**CLEVELAND HOPKINS
INTERNATIONAL AIRPORT
CLEVELAND, OHIO**

Project Title RTA TUNNEL MEMBRANE REPLACEMENT			
Sheet Title SHEET INDEX AND SUMMARY OF QUANTITIES			
Designed: MSI	Drawn: MSI	Checked: LGW	Approved: LGW
Scale: AS SHOWN		Project No.: 198348	
Date: FEBRUARY 2024		Sheet: C-2

2/26/2024 Prebid Questions:

Sheet Title: TYPICAL SECTIONS - 2			
Designed:	Drawn:	Checked:	Approved:
MSI	MSI	LGW	LGW
Scale: AS SHOWN		Project No.: 198348	
Date: FEBRUARY 2024		Sheet: C-6

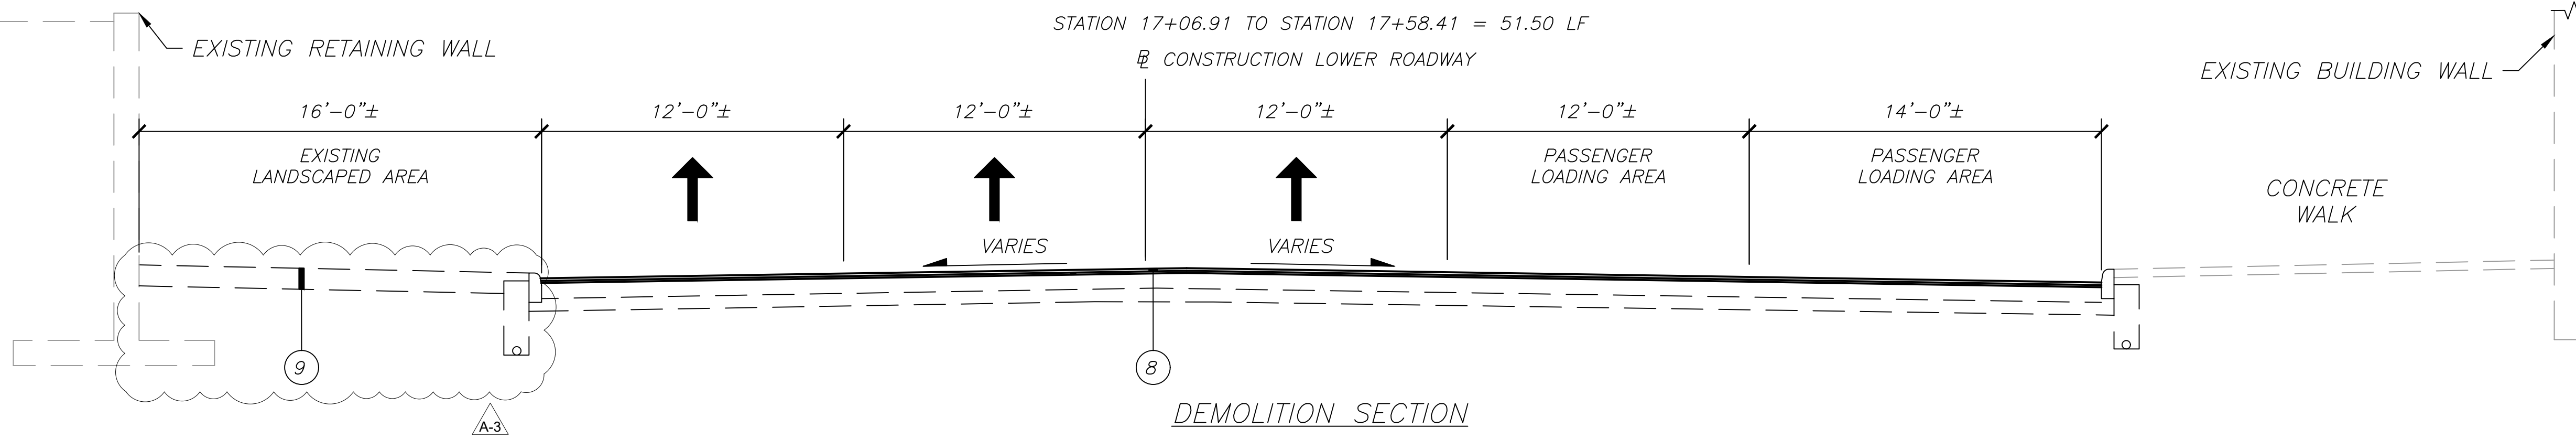
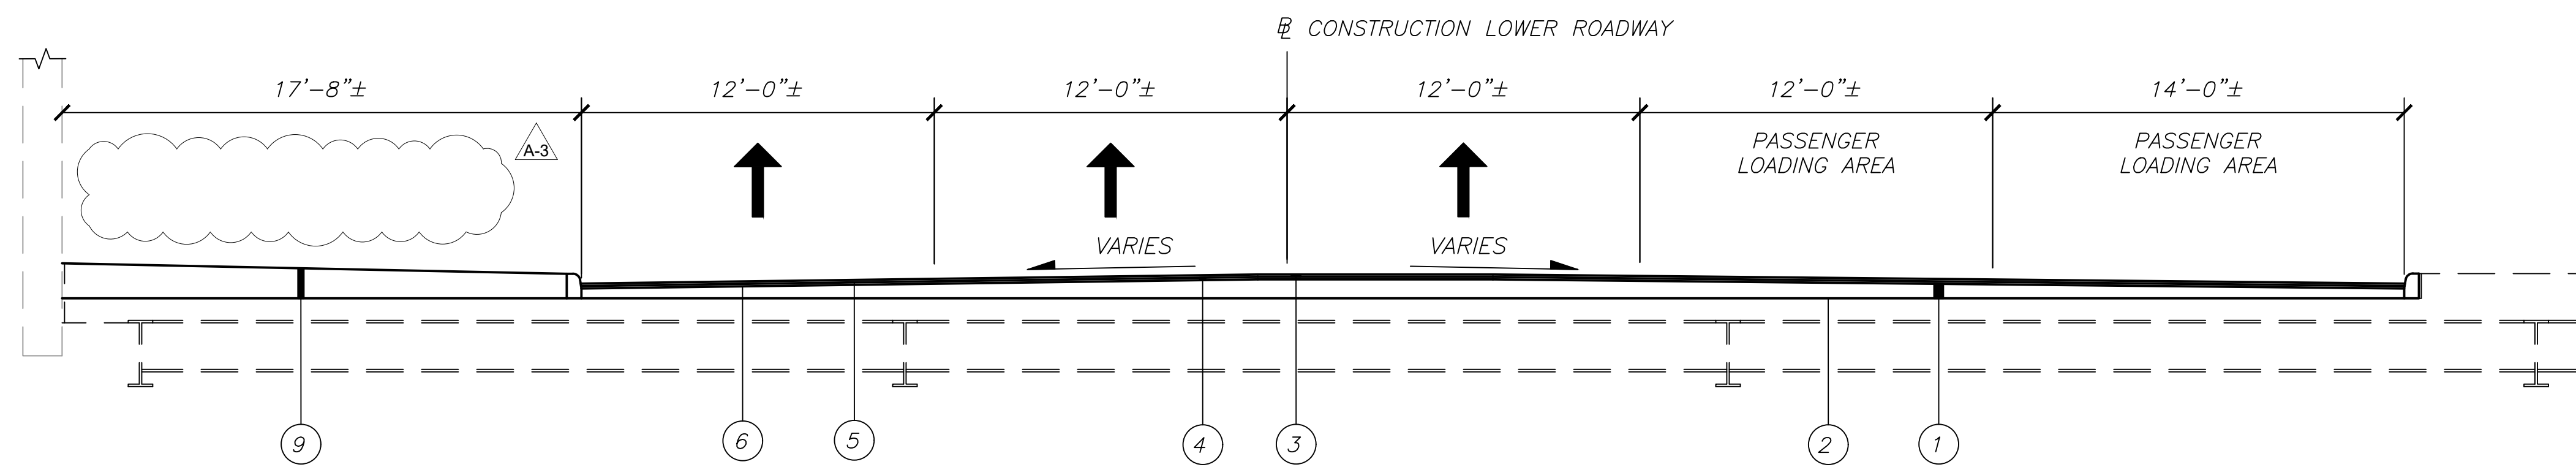
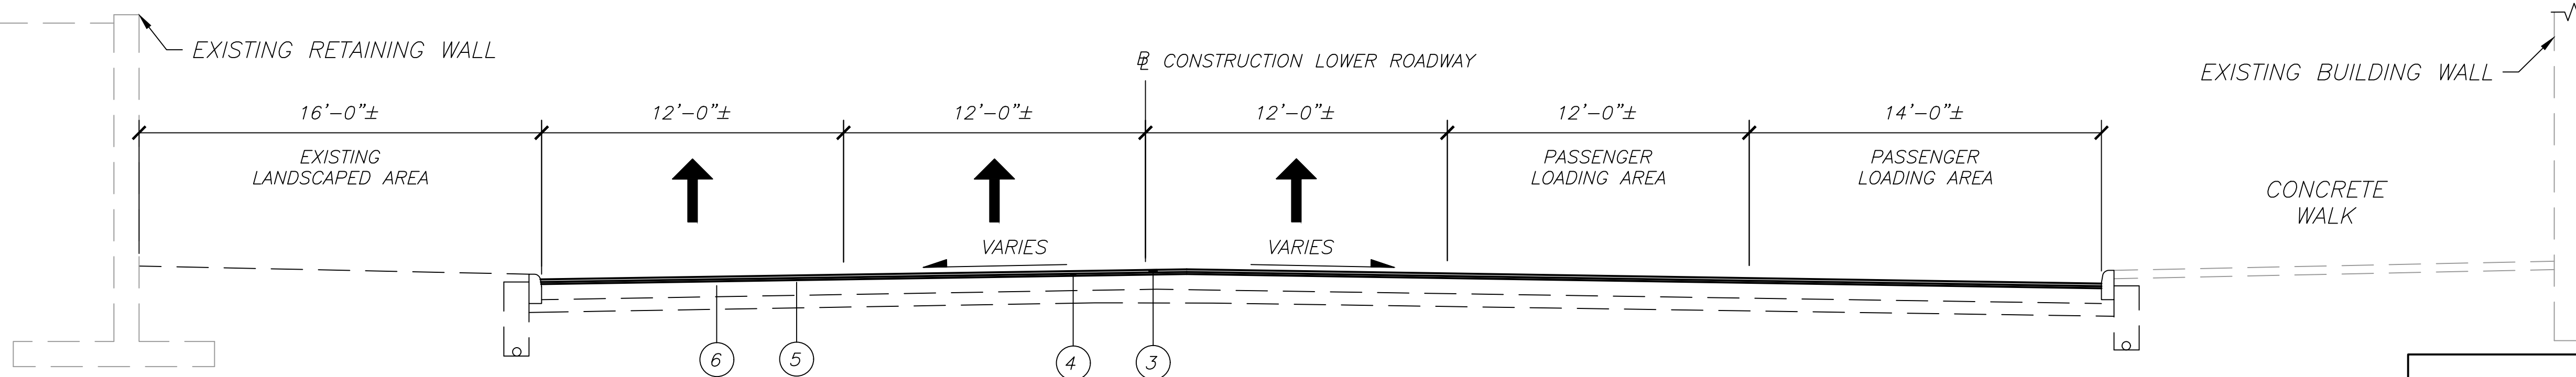
Question: Plan Sheet C-6 states to install foam flashing Per Sheet "XX". There is no plan sheet "XX" included in the plans. Please clarify.

Question: Proposed Typical Section on Plan Sheet C-6 details 10" concrete walk removed and reconstructed from Station 17+06.91 to Station 17+58.41 = 51.50 LF. However Plan Sheet C-7 shows begin sidewalk replacement at STA 16+72.65 and ending at STA 17+89.24. Please clarify.

Answer: The foam flashing detail has been removed. Please see Sheet C-19 for flashing details.

Answer: Please see revised drawings.

D751 BOX INLET
SCALE: NTS

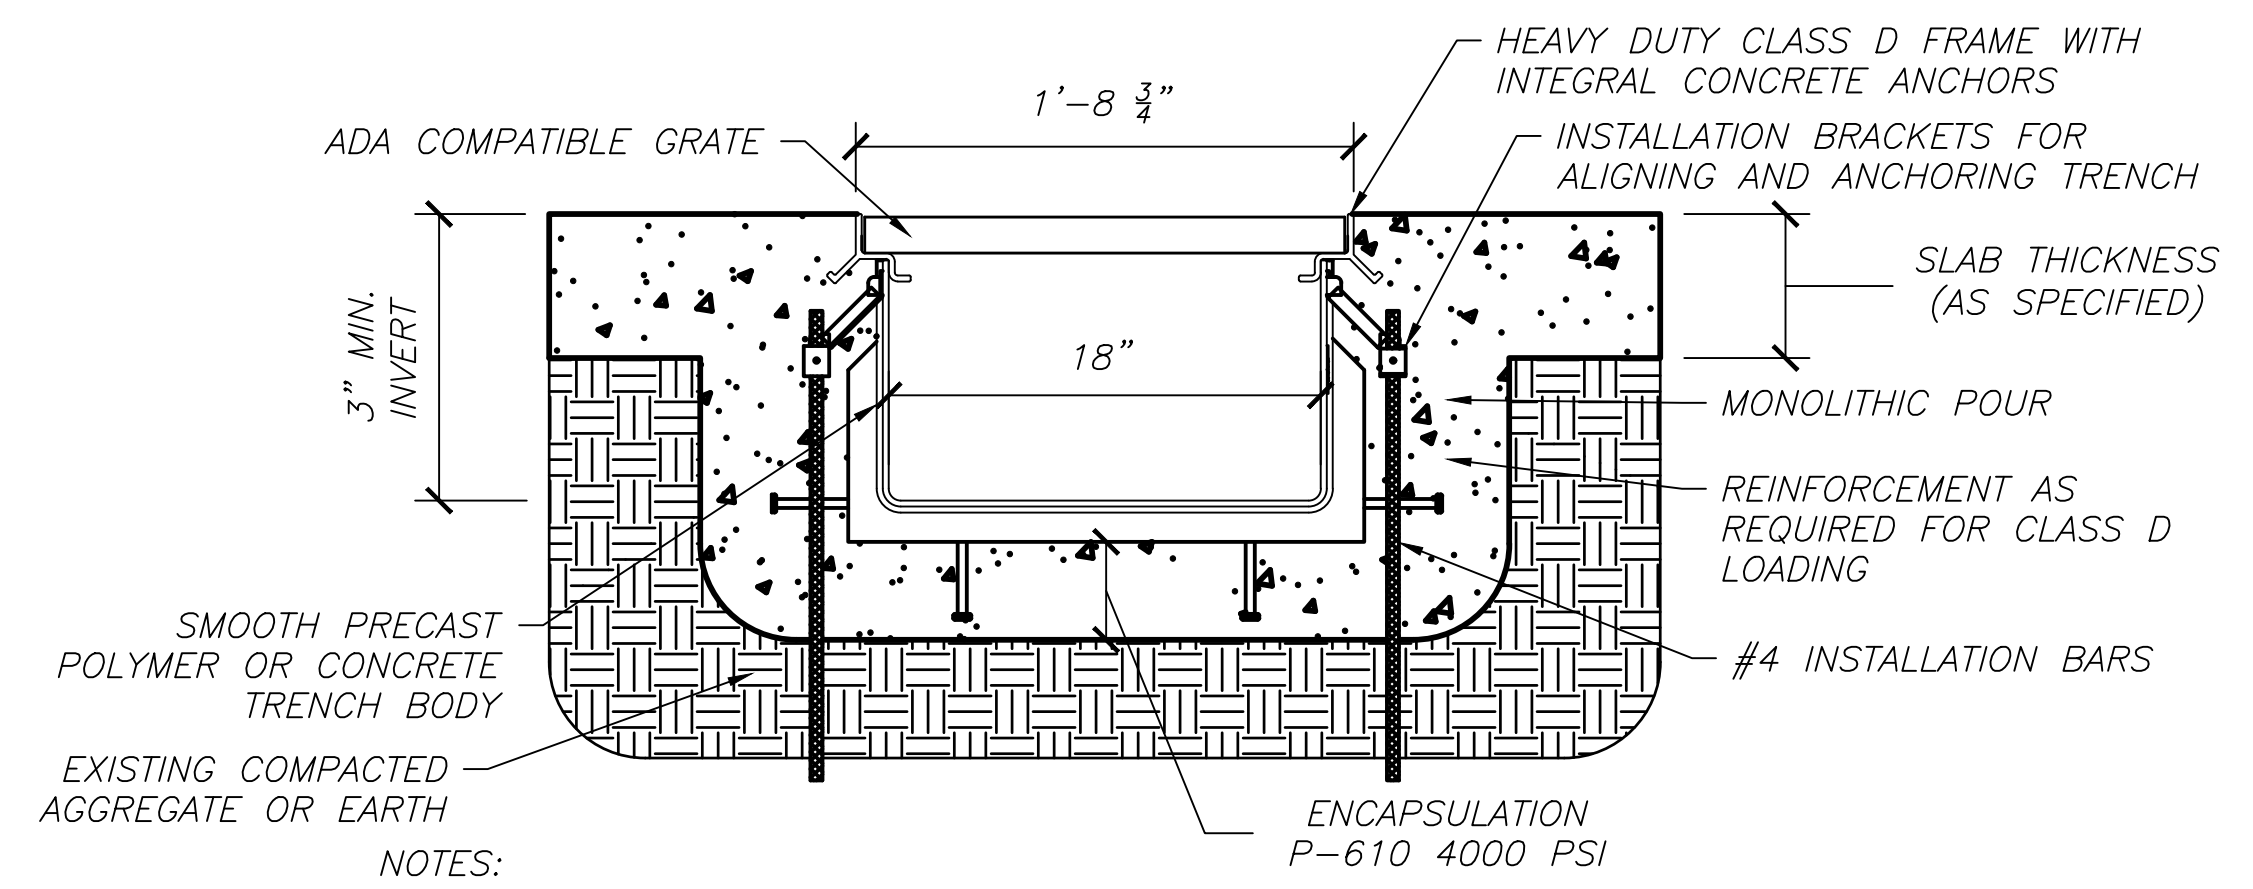
Question: Specification D-751 does not provide information for the standard to follow in selecting the box inlet. Please provide.

Question: Specification D-751 does not state whether the grate for the box inlet needs to provide heel proof protection. Please clarify.

Answer: Please see revised drawings.

Answer: Please see the revised drawings. Grates must be ADA compliant.
